Interactive comment on “GSFLOW-GRASS v1.0.0: GIS-enabled hydrologic modeling of coupled groundwater–surface-water systems” by G.-H. Crystal Ng et al.

RESPONSE TO REVIEWER 1

Fig. 1. Screenshot of GRASS GIS' new features - includes GSFLOW-GRASS add-ons

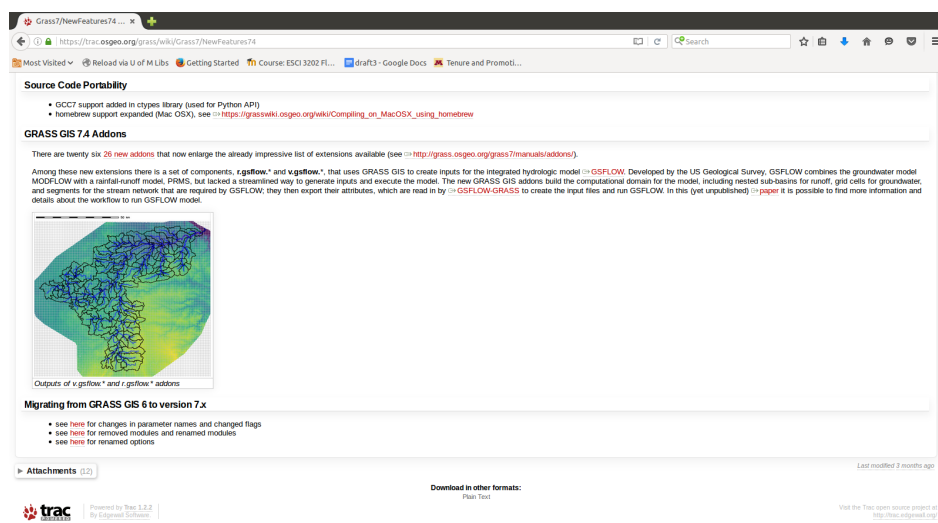
The technical advancements of our GRASS GIS tools were recently highlighted as a new release feature on the GRASS GIS website: <https://trac.osgeo.org/grass/wiki/Grass7/NewFeatures74> (including a figure with our Cannon River watershed example)

– see the screenshot in Figure 1.
